V2500 Propulsion System — Nacelle

SERVICE BULLETIN

Subject: Transmittal of Revision 2 to Service Bulletin Number V2500-NAC-71-0256

NACELLE - POWERPLANT – RIGHT HAND FAN COWL DOOR – MODIFICATION TO LATCH
ASSEMBLY

Removal of Anti-swivel Plate – Fan Cowl Door Latches 1,2,3 and 4
Figure 1 Sheet 1 of 1

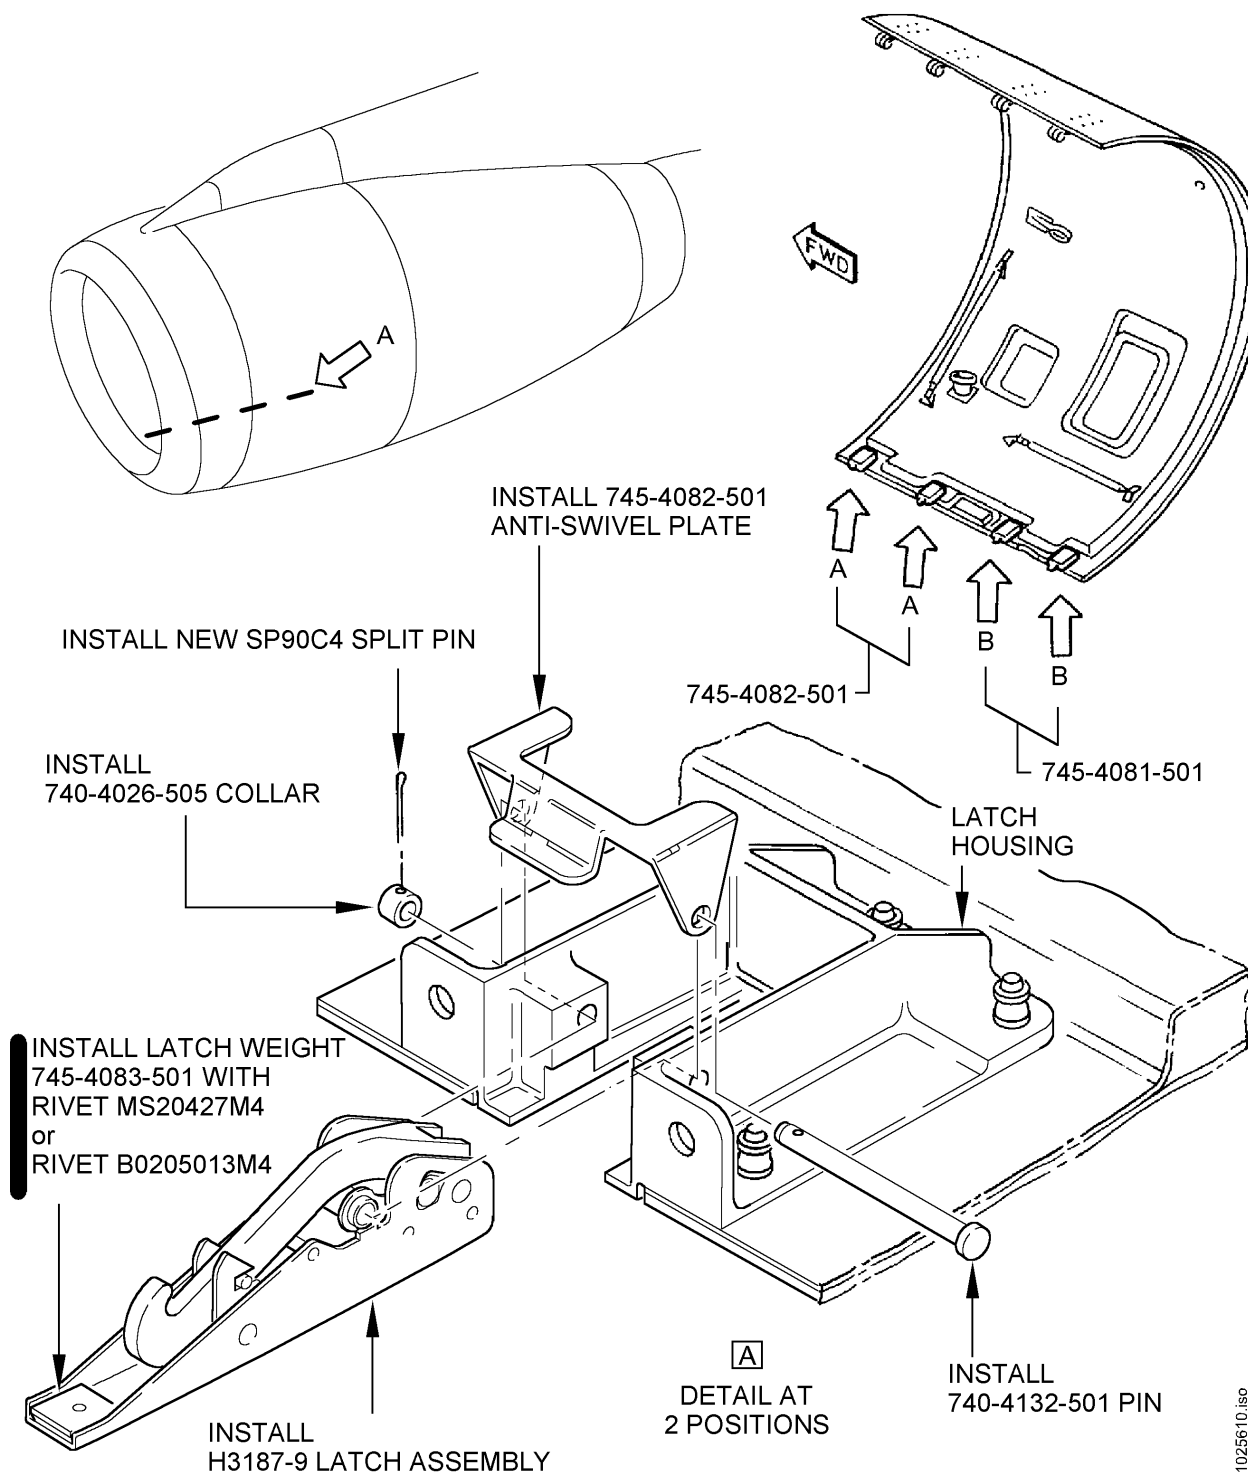
- (1) Remove and discard the SP90C4 Split Pin as shown at latch 1. Remove the 740-4026-505 collar. Refer to Figure 1 sheet 1.
- (2) Remove the 740-4132-501 Pin which holds the H3187-1 or H3187-9 Latch Assembly and the 740-4027-507 Anti-swivel Plate.

- (3) Remove the 740-4027-507 Anti-swivel Plate and the H3187-1 or H3187-9 latch Assembly as shown. Discard the Anti-swivel Plate.
- (4) Put the 745-4083-501 Latch Weight in position on the H3187-1 or H3187-9 Latch Assembly as shown. Hold the Latch Weight and drill a hole 0.128" (3.25mm) dia. from the Latch Weight through the Latch Assembly.

Installation of Anti-swivel Plate and Latch Weight – Fan Cowl Door Latches 1 and 2
Figure 2 Sheet 1 of 2

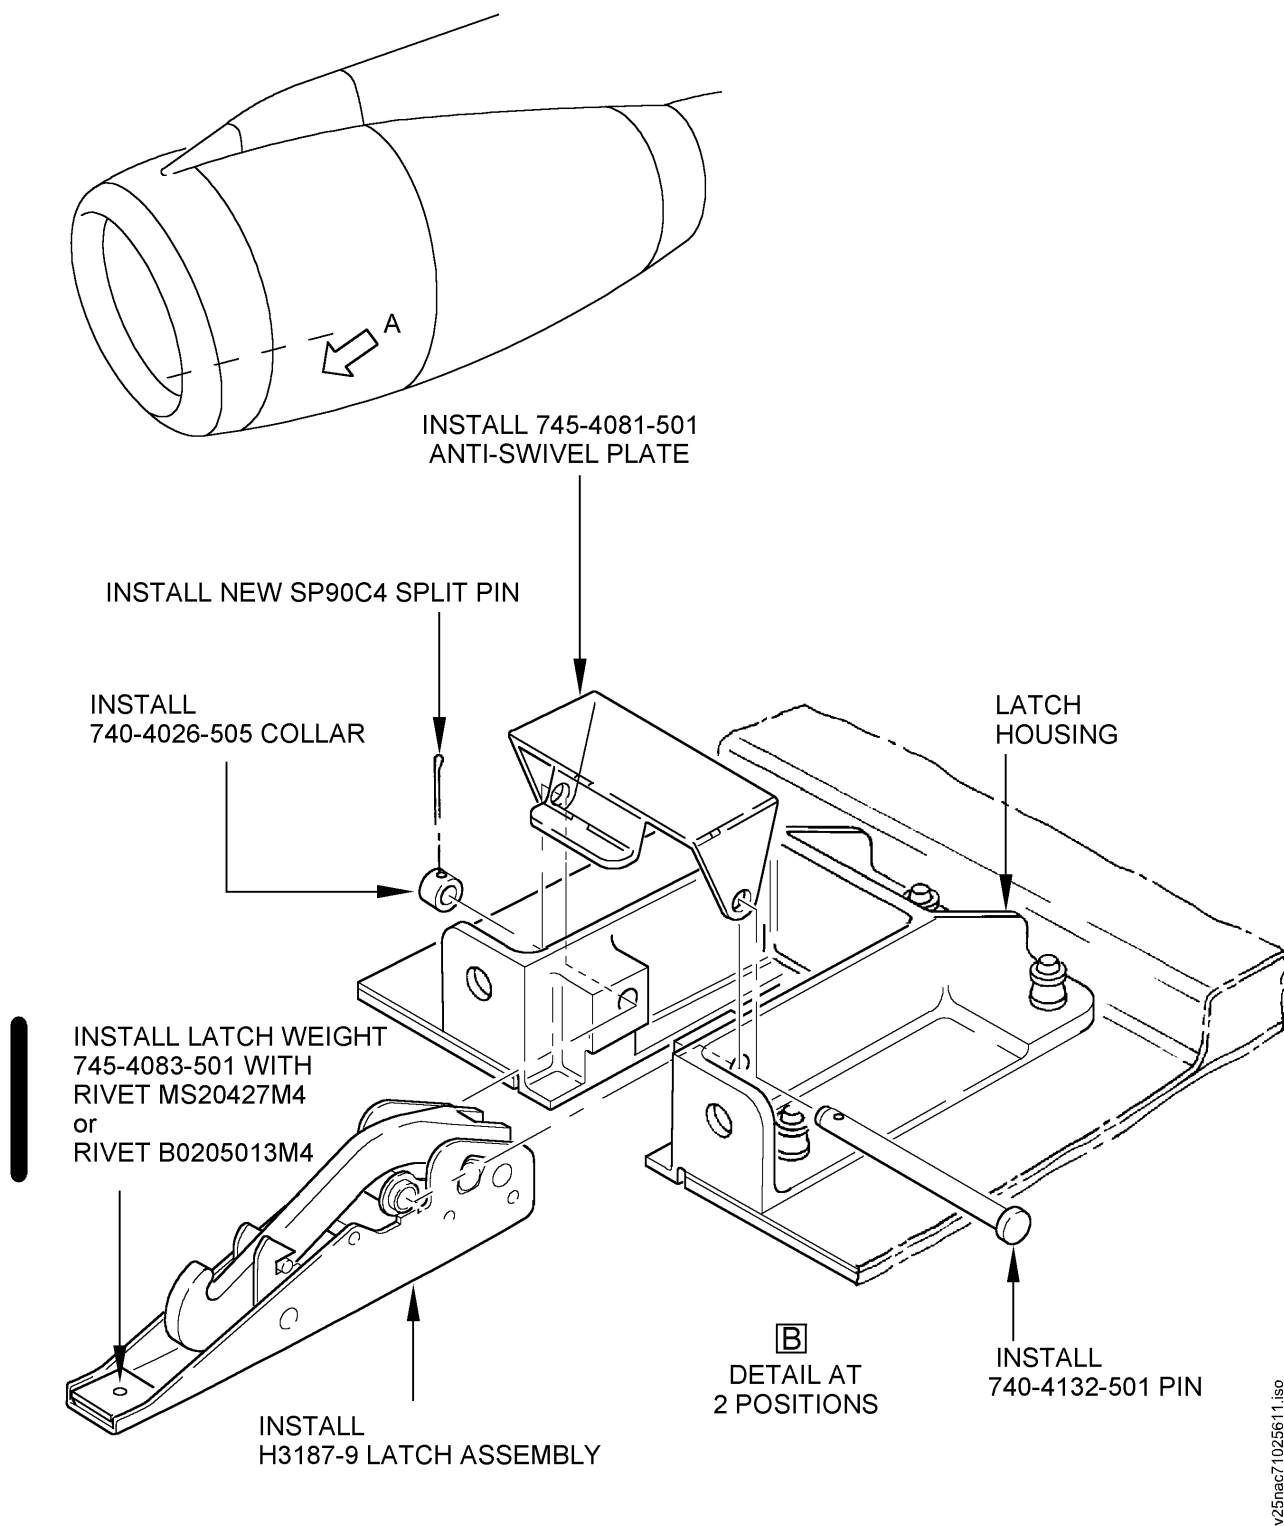
- R (7) Install the 745-4083-501 Latch Weight to the H3187-1 or H3187-9 Latch Assembly with an MS20427M46-5 or B0205013M4-6 Rivet and make flush at both ends. Cut the rivet to a suitable length to fill the countersink in the Handle of the Latch Assembly. Refer to Figure 2 sheet 1.

CAUTION: MAKE SURE YOU INSTALL THE ANTI-SWIVEL PLATES AT THEIR CORRECT LOCATION AS DETAILED ON FIGURE 2, DETAIL 'A' AND 'B'. THE ANTI-SWIVEL PLATES MAY CONTACT AND DAMAGE ADJACENT COMPONENTS ON CLOSING OF THE FAN COWL DOORS IF INCORRECTLY INSTALLED

- (14) Install the H3187-9 Latch assembly to the Latch Housing as shown with the new 745-4082-501 Anti-swivel Plate, the 740-4132-501 Pin, and 740-4026-505 Collar. Make the Pin safe with a new SP90C4 Split Pin.
- (15) Make sure that the H3187-9 Latch Assembly has unrestricted movement through its limit of travel and is not impeded by its clearance with the Latch Housing.
- (16) Do steps (1) thru (15) to install a new 745-4082-501 Anti-swivel plate at latch 2.
- (17) Do steps (1) thru (15) except install a new 745-4081-501 Anti-swivel plate in place of the 740-4027-507 Anti-swivel Plate at latch 3. Refer to Figure 2 sheet 2.
- (18) Do steps (1) thru (15) except install a new 745-4081-501 Anti-swivel plate in place of the 740-4027-507 Anti-swivel Plate at latch 4. Refer to Figure 2 sheet 2.
